The Town of Niagara-On-The-Lake

Report: UDC-21-003

Report To: Urban Design Committee
Subject: 56 Kenmir Avenue
Proposed New Dwelling

SITE PLAN
SCALE = 1:150

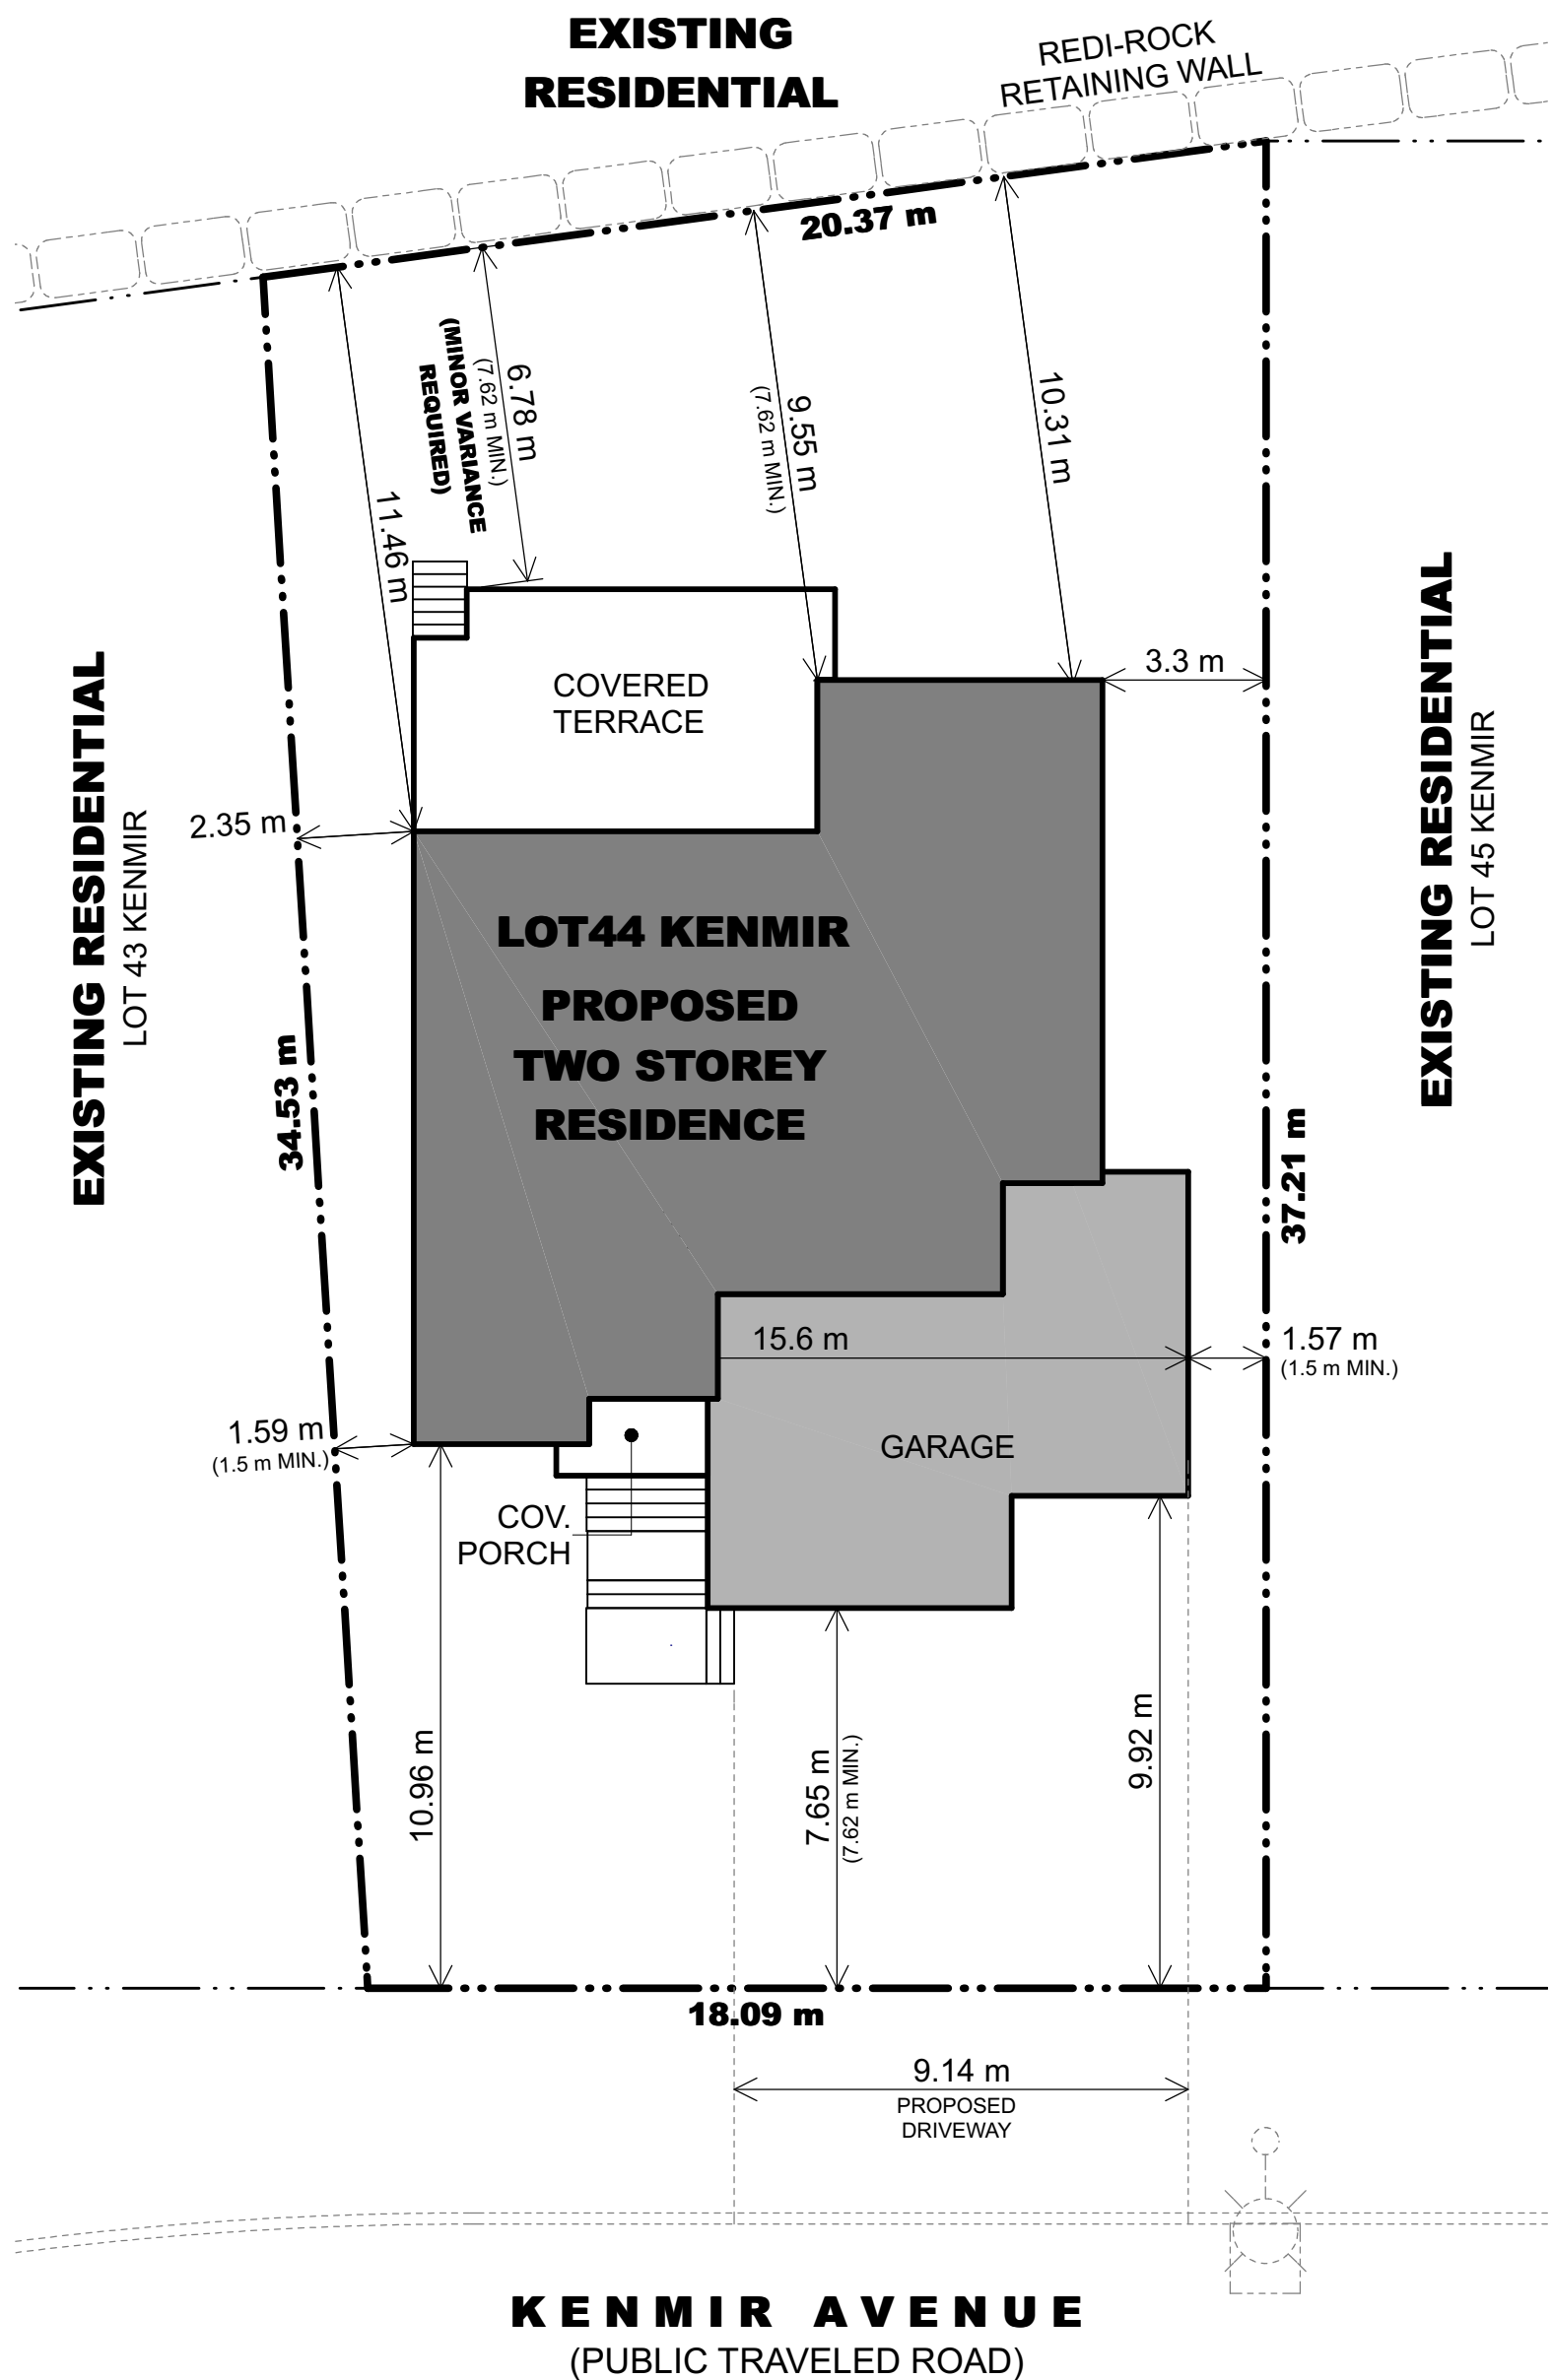
SITE STATISTICS:	
LOT AREA	- 687.59 m ²
LIVING AREA	- 158.49 m ²
GARAGE	- 61.78 m ²
COV. PORCH	- 4.27 m ²
COV. TERRACE	- 40.41 m ²
TOTAL	- 264.95 m ² (38.6%)
MINOR VARIANCE REQUIRED FOR LOT COVERAGE (33% MAX)

FRONT ELEVATION
SCALE = 1:100

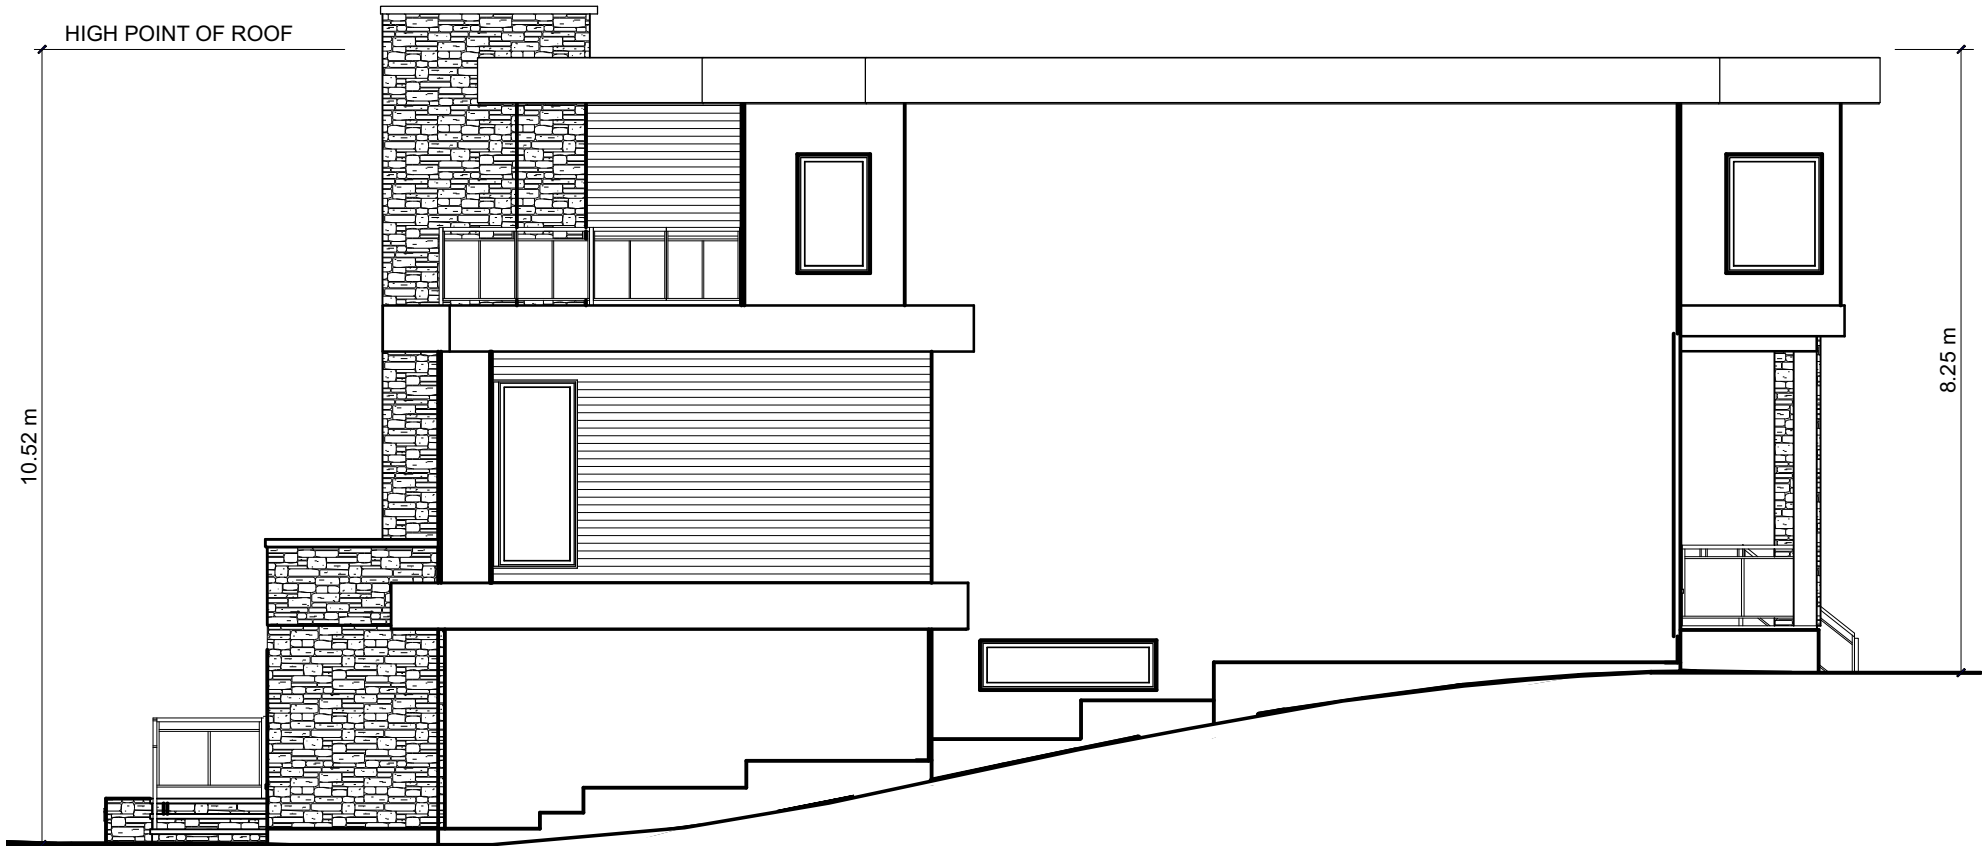
The proposed design is generally consistent in form and design with existing dwellings in the St. Davids Estates Subdivision, which is a sub-neighbourhood defined by large, custom homes of varying architectural styles. The double-wide garage is proposed to project in front of the dwelling facade, which is discouraged in the design guidelines. There are other examples within the subdivision in which garages project in front of the dwelling facade incorporating a balcony directly above (see **Appendix II**). The balcony above the garage creates an active interface with the street, but does not diminish the visibility of the garage.

The proposed dwelling design incorporates a 3-car wide garage with a single-car garage door and a double-wide garage door. The total width of the garage doors is approximately 7.3 metres, which is less than 50% the width of the street facing

The design guidelines recommend that garages be recessed from the front facade, however, as noted previously, the garage projects in front of the dwelling facade and front porch. Living space, as well as a balcony are proposed above the garage. The covered portion of the front porch is less than 2 metres in depth as recommended in the design guidelines. A 2 metre depth is encouraged in order to promote the active use of a front porch and more "eyes on the street." However, the applicant is proposing a balcony above the garage, which could serve as an alternative active space on the dwelling facade.

The guidelines state that for lots over 12.2 metres, garage interior widths shall be a maximum of 6 metres in width. The proposed dwelling exceeds the 6 metre maximum and proposes an interior width of 9.4 metres for the proposed 3-car garage. In addition, the guidelines recommend 2 (two) single width garage doors in preference to a double width door. The proposed dwelling includes both a single and double-wide garage door. Staff note that double-wide garage doors are used on many of the surrounding dwellings. The applicant has considered the use of a hidden garage door for the single garage door in order to mitigate the aesthetic impacts of the proposed 3-car garage from the street. Alternate drawings showing a hidden garage door option are provided in **Appendix III**.
